ADDENDUM # 2

Bid 21C4, Gov. Thomas Johnson High School Roof Replacement Project

FREDERICK COUNTY PUBLIC SCHOOLS
GOV. THOMAS JOHNSON HIGH SCHOOL
AREA 'I' - ROOF REPLACEMENT

ADDENDUM NO. 2
January 28, 2021

ROOF
PLAN / NOTES

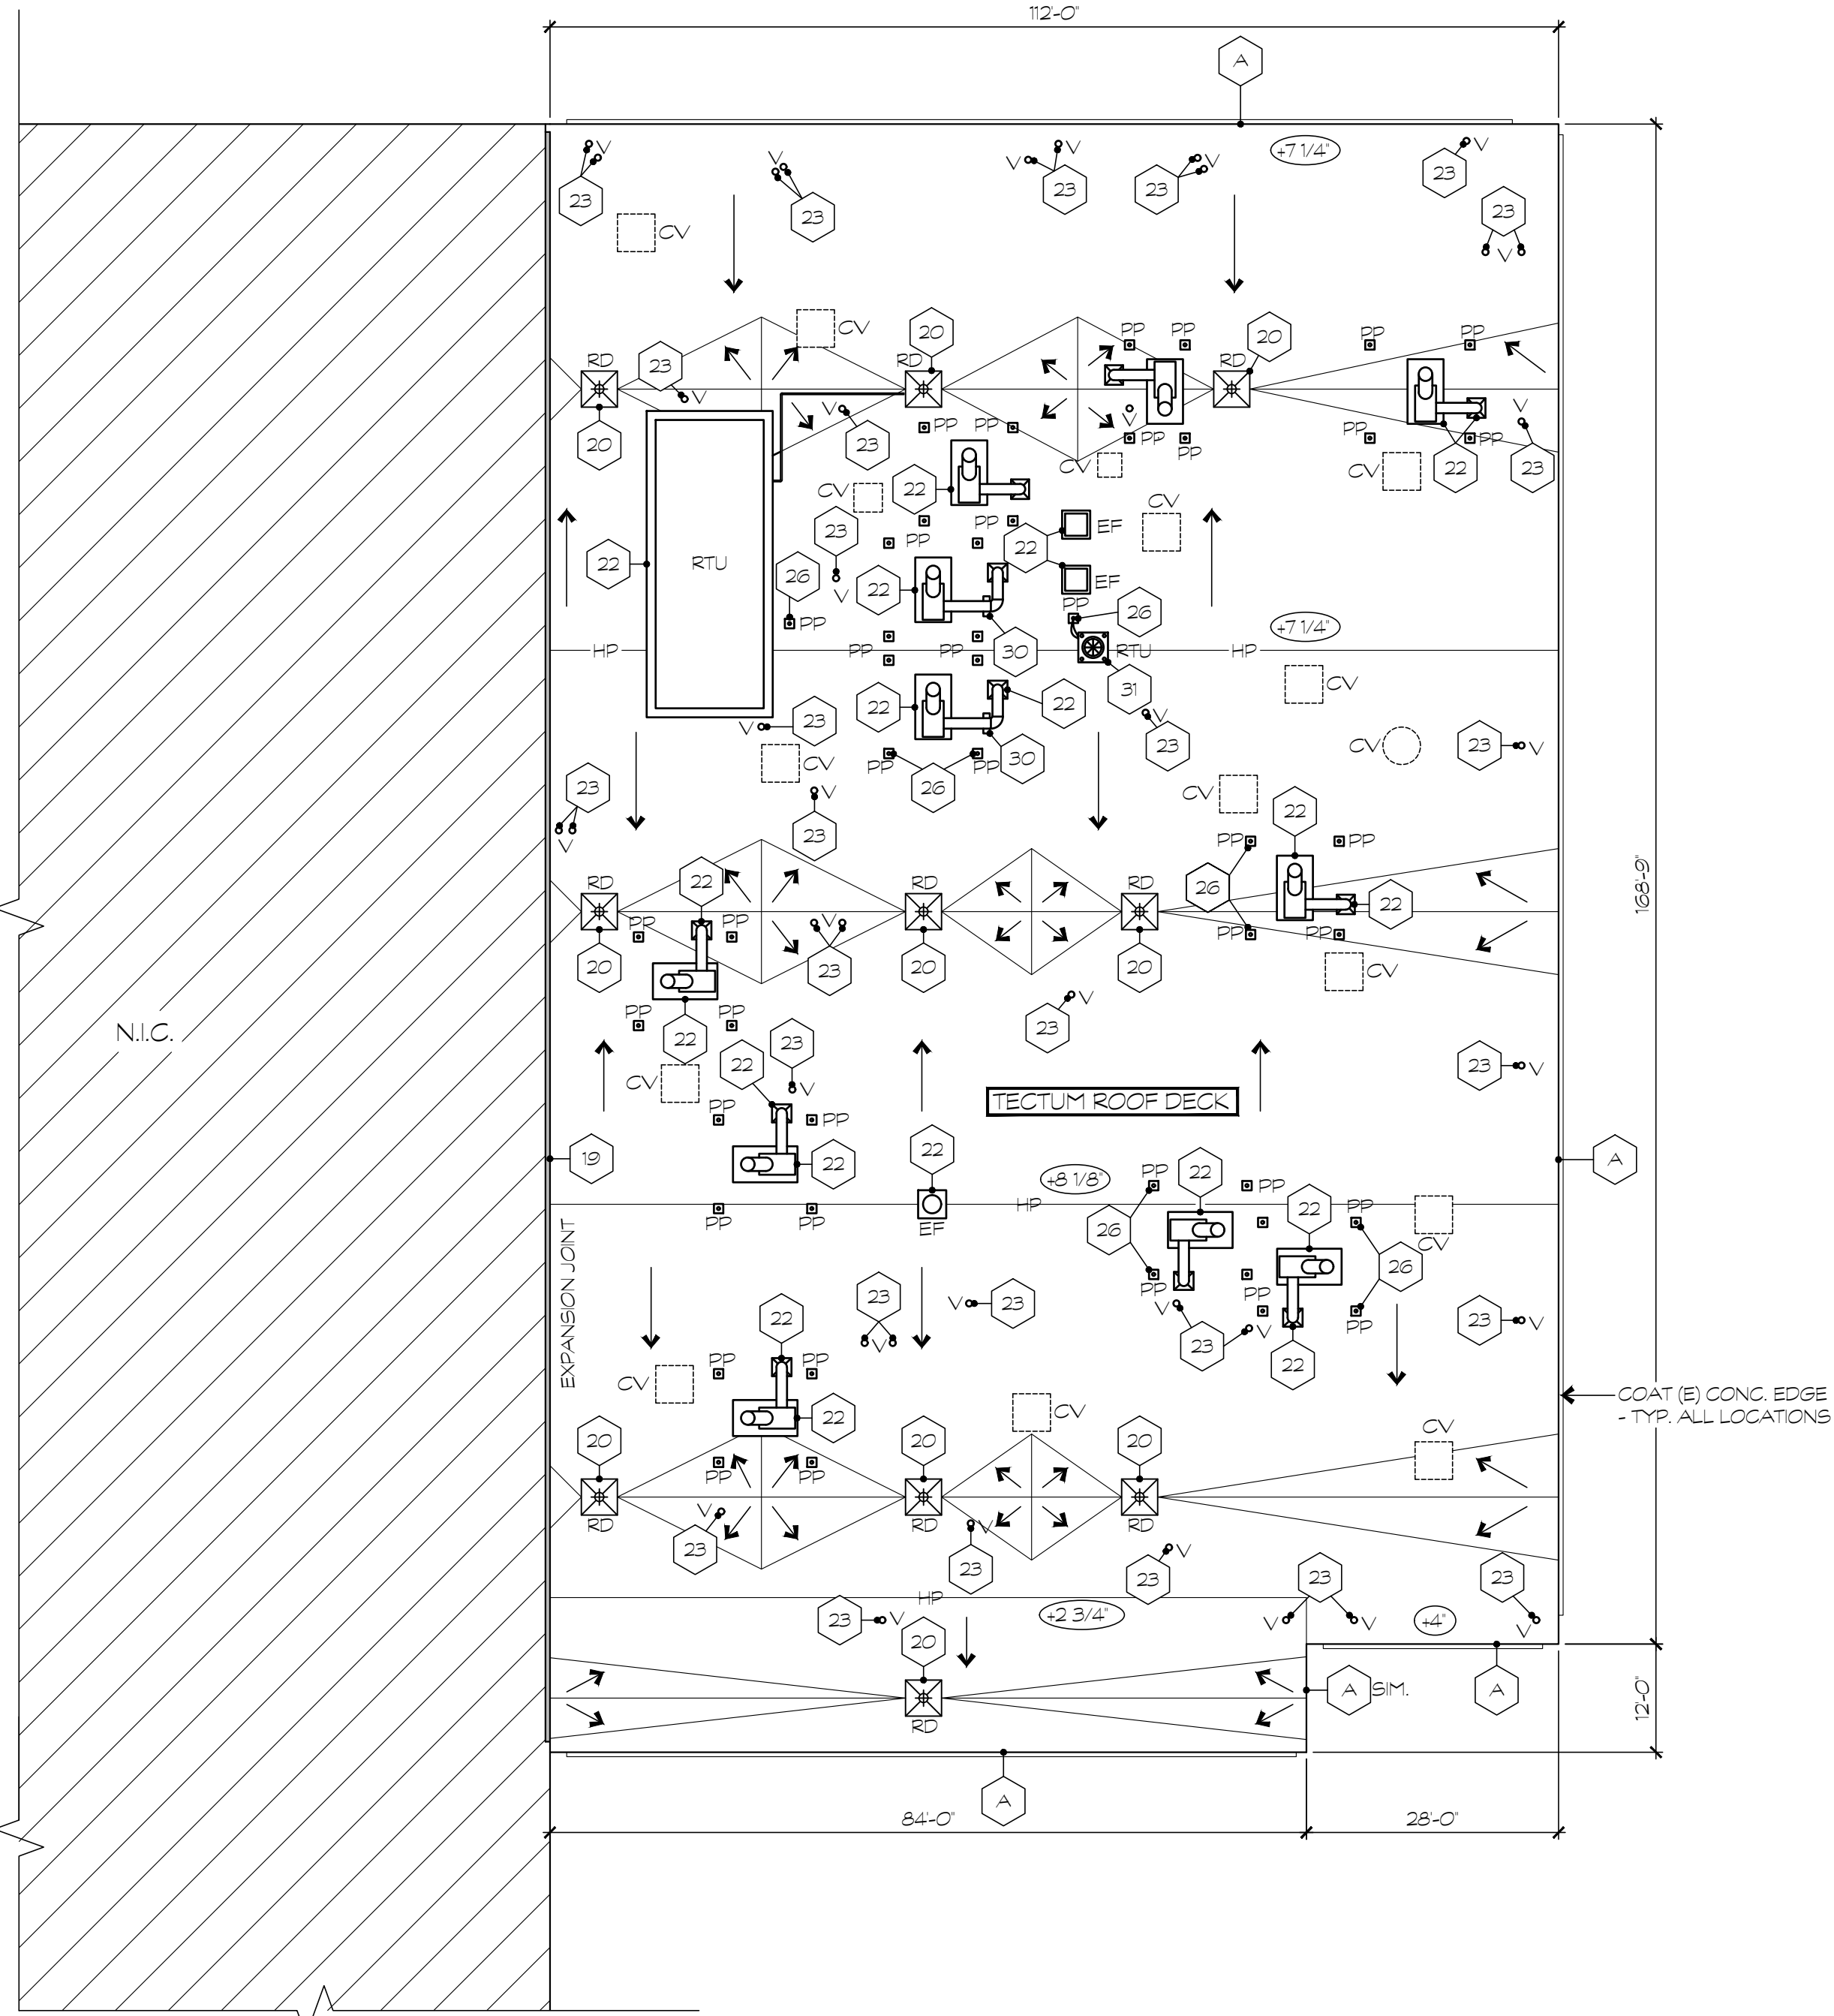
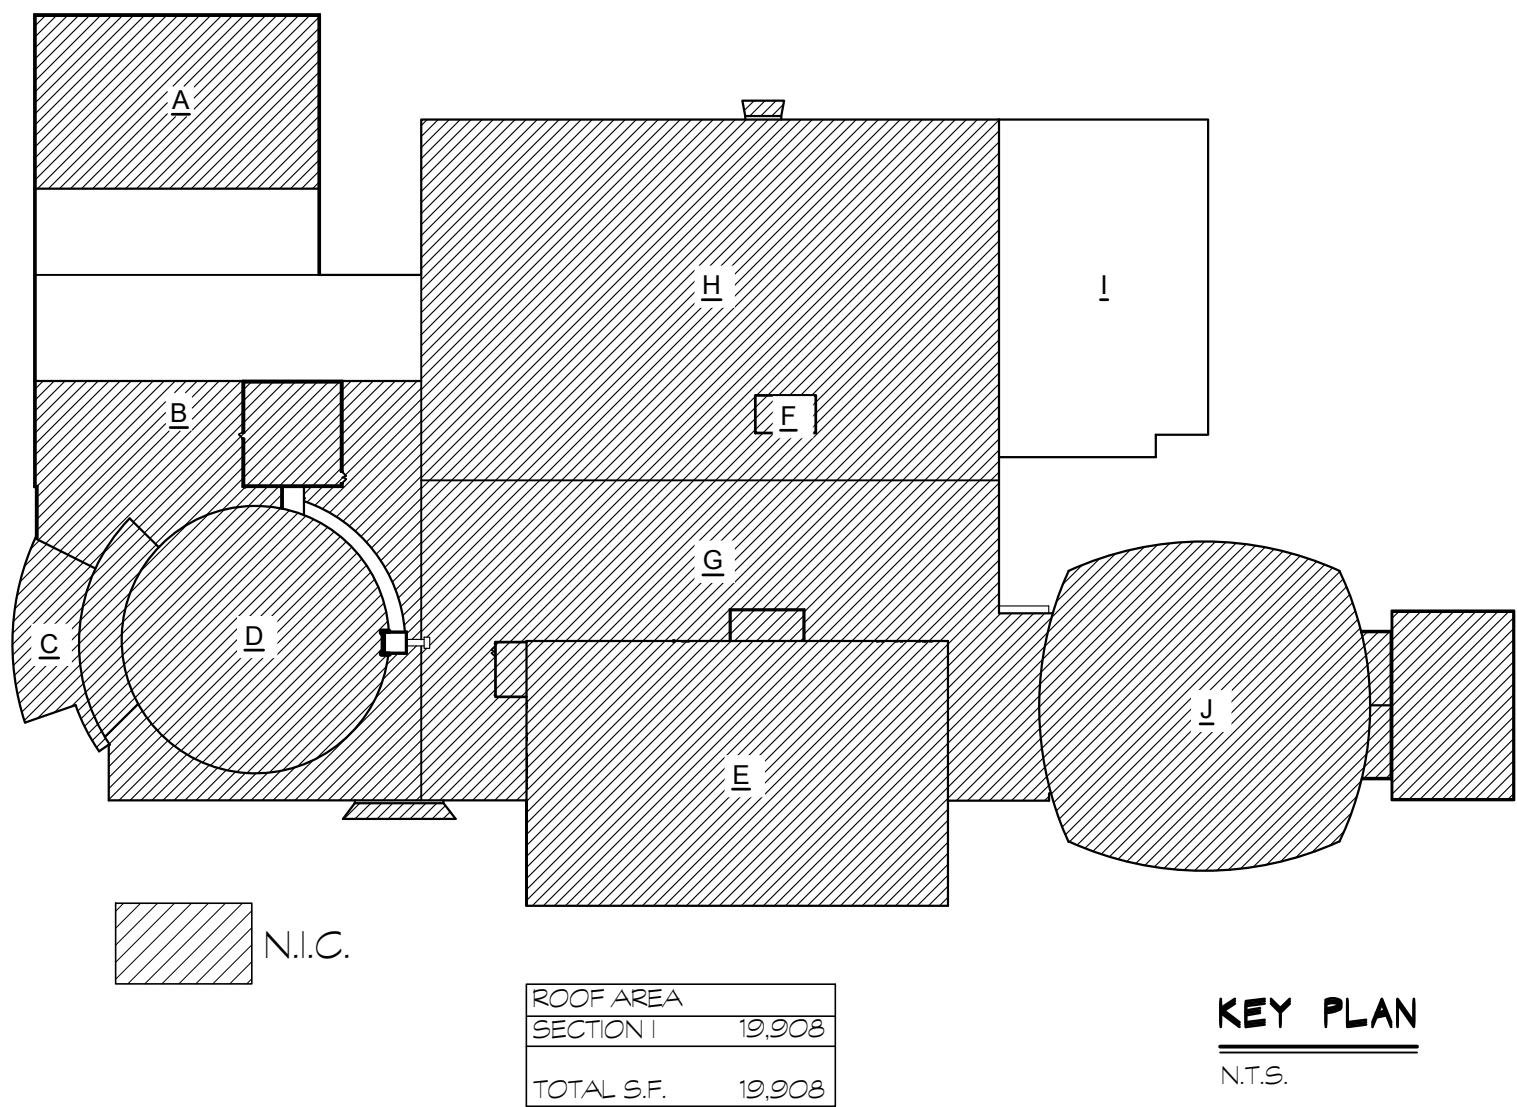
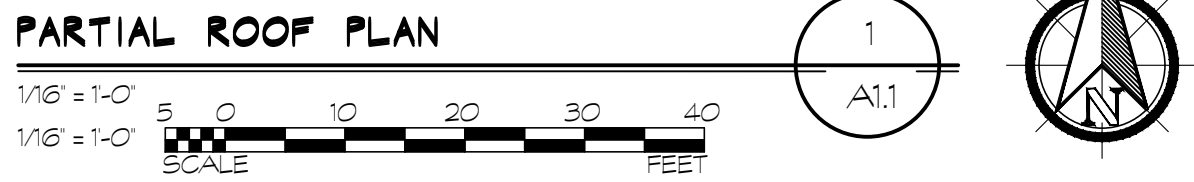
ITEM NO. 2.07 DRAWINGS CS.1, A1.1, A1.2, & A1.3; DELETE all drawings in their entirety. INSERT the REVISED drawings included in this addendum as attachment no.1 (4 pages (drawings)), Dated Jan 28, 2021. This includes drawings CS.1, A1.1, A1.2, & A1.3.
